SUMMARY OF MEETING WITH TOLEDO EDISON COMPANY REGARDING THE DAVIS
 BESSE NUCLEAR POWER STATION, UNIT 1 SEPARATION CRITERIA

MEETING SUMMARY, OCTOBER 28, 1976
DAVIS BESSE, UNIT 1

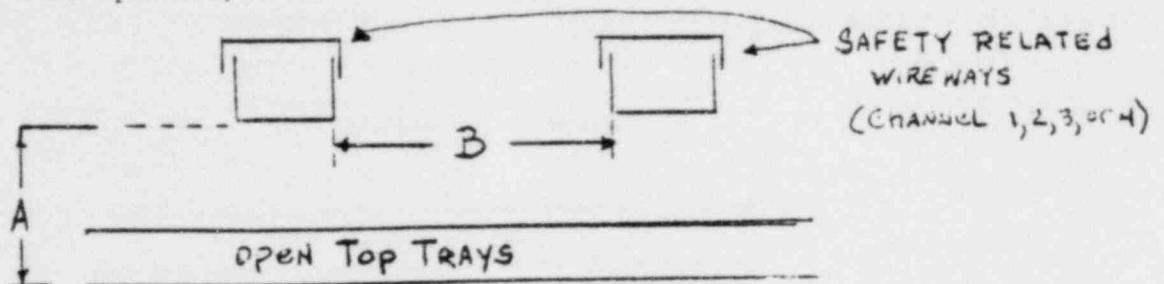
3. The applicant agreed to document in the FSAR the following criteria for redundant safety related wireways when routed over open trays.

- a. If "A" is less than 46 inches, adequate barriers extending horizontally no less than 12 inches to each side of the wireway between the open tray and the wireway, will be provided to preclude fire damage of redundant safety related wireways in the event of fire in the open tray.
- b. If "B" is less than 24 inches, an adequate fire barrier will be provided between the redundant wireways.
